R. E. Ginna Nuclear Power Plant
Renewed Facility Operating License No. DPR-18
NRC Docket No. 50-244

Subject: Supplemental Information Associated with the License Amendment Request to Add a One-Time Note for Use of Alternate Residual Heat Removal Methods

Attachment 2
Supplemental Information

Figure 1:
Water Solid Steam Generator
Cooldown Flow path

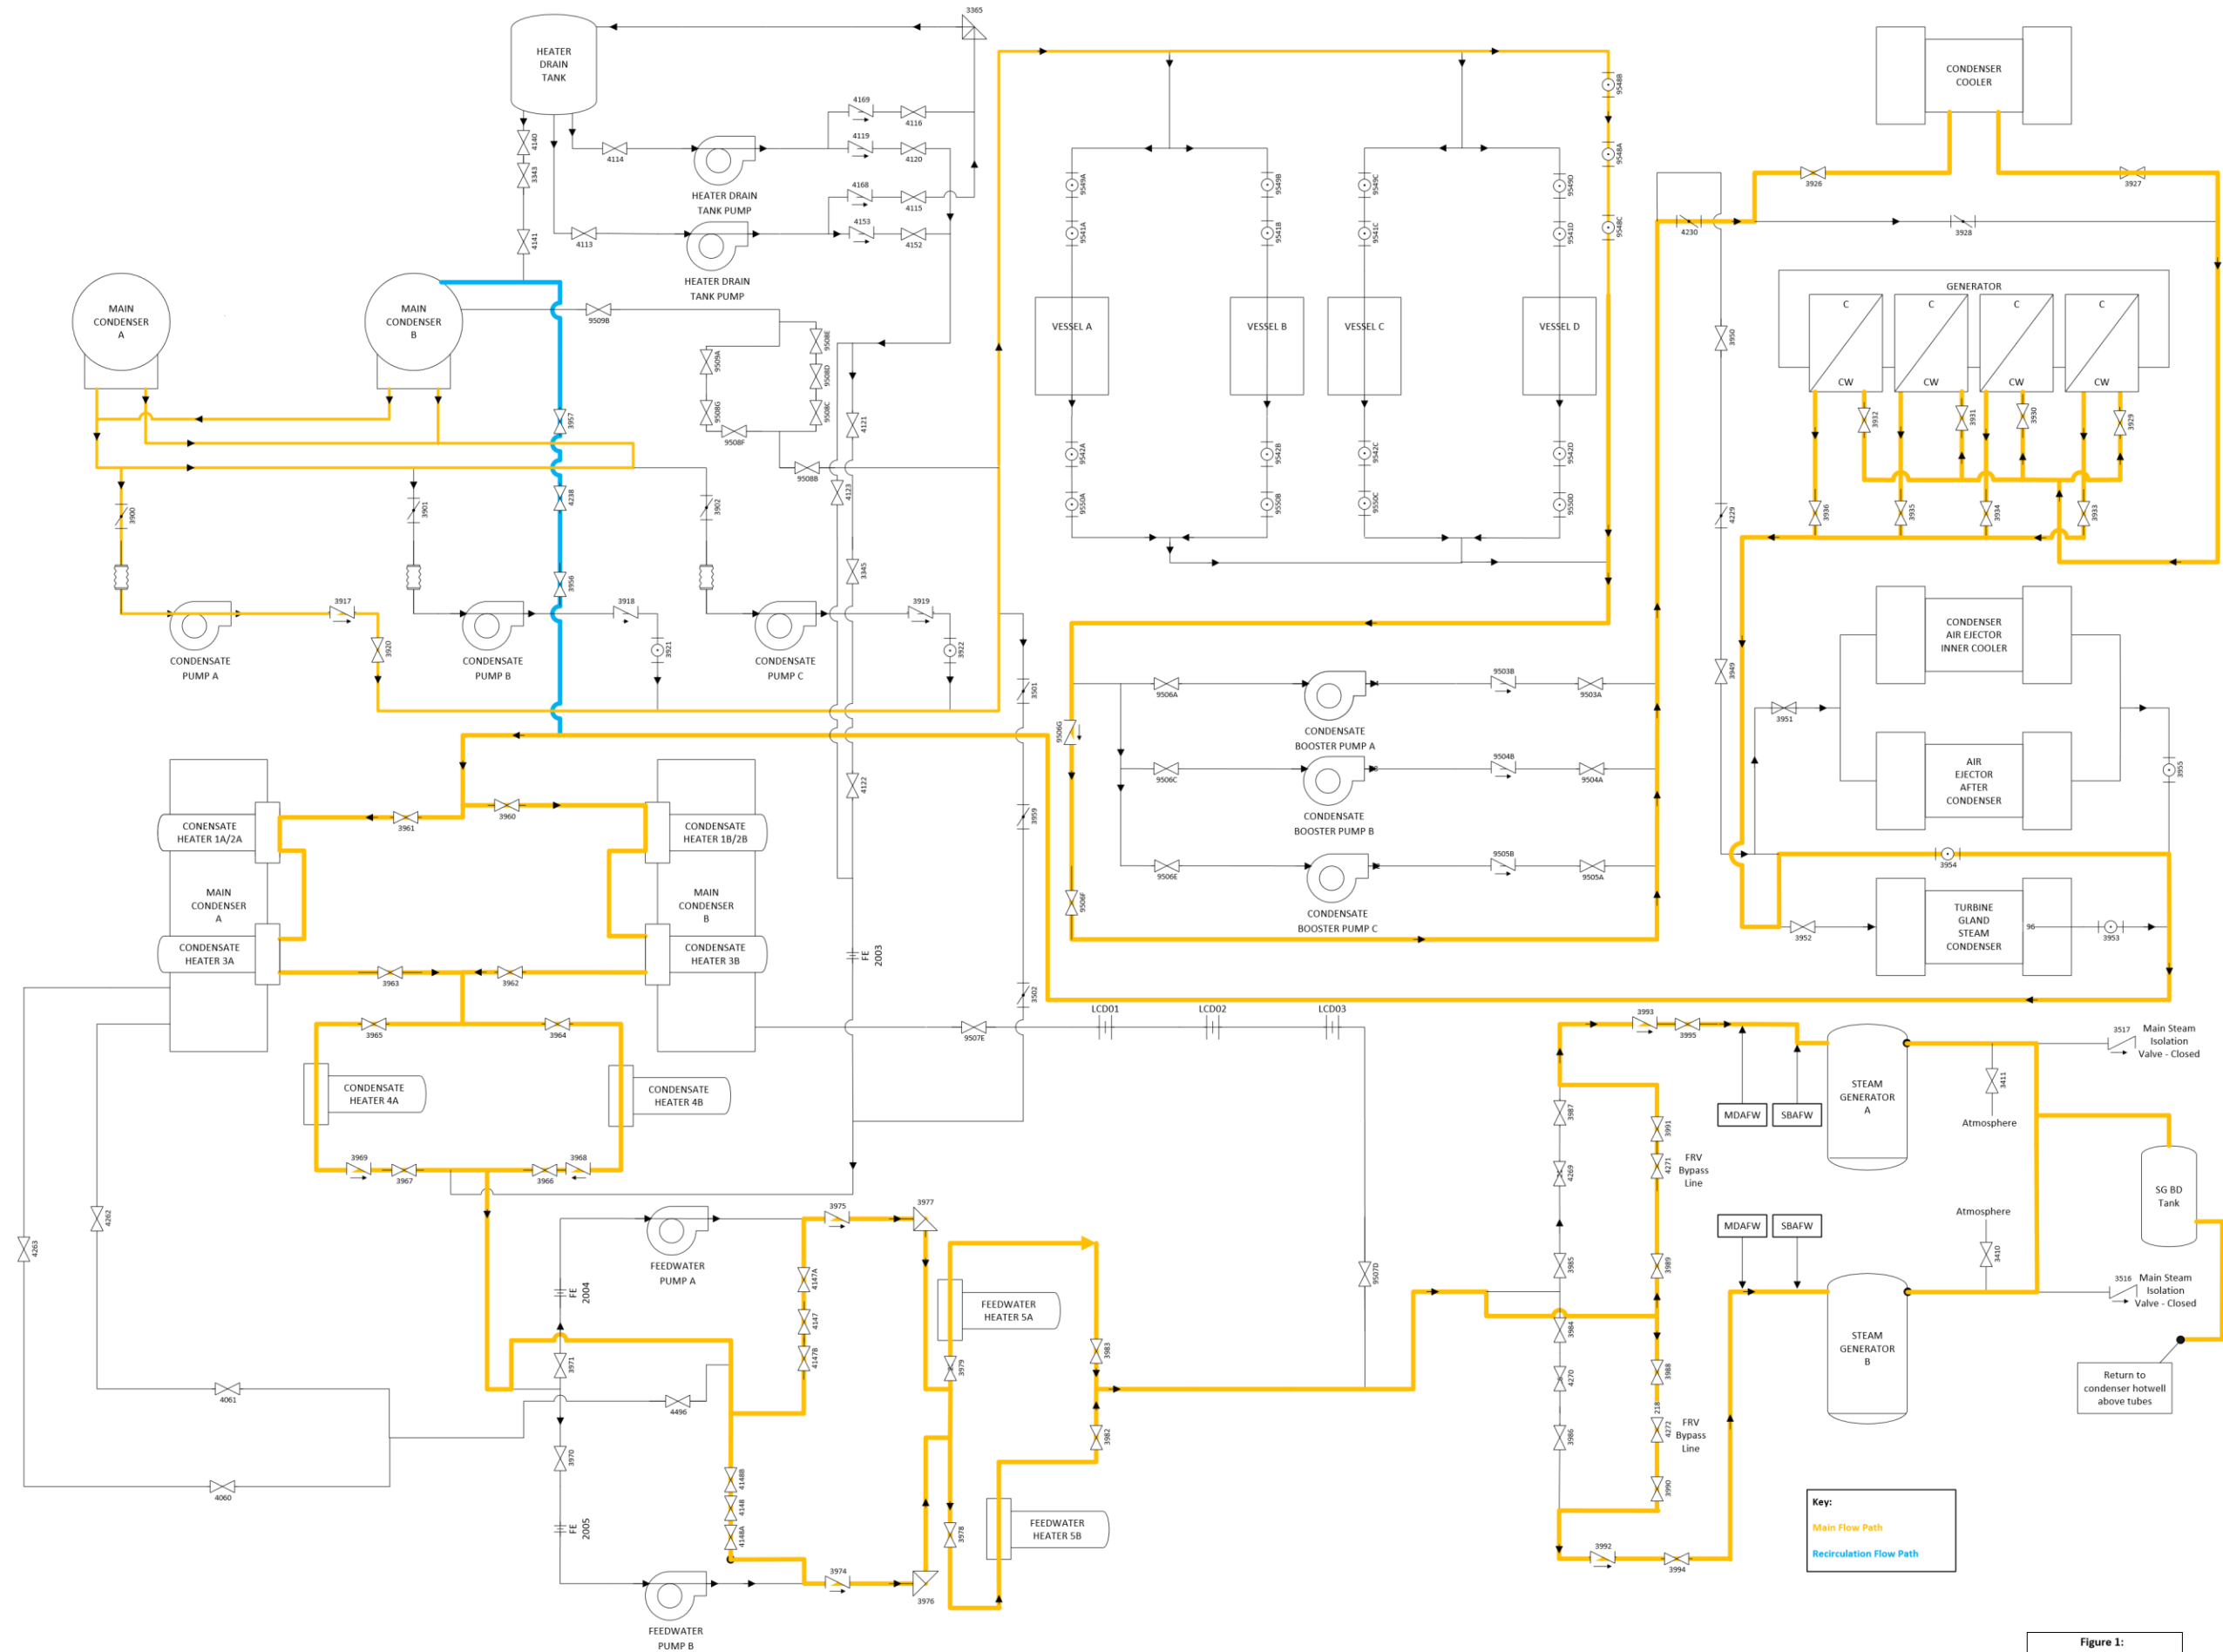
"4. Add a figure into the License Amendment Request Technical Evaluation for the solid Steam Generator cooldown flowpath, as well as a table comparing Reactor Coolant Pump and decay heat loads with the capacity of the condensate cooling method."

Figure 1 shows the water-solid Steam Generator cooldown flow path. The decay heat loads are shown above in the response to Question 3, and the heat addition due to a Reactor Coolant Pump running is 17.1 MBTU/hr. The condensate cooler was determined to be capable of removing 53.9 MBTU/hr at peak summer conditions (conservative for this evaluation due to higher assumed cooling water temperature) with the Reactor Coolant System at 300°F; therefore, the heat removal with a Reactor Coolant Pump running will match decay heat at approximately 16 hours post-shutdown. This is the expected time that water-solid Steam Generator cooldown would be initiated.
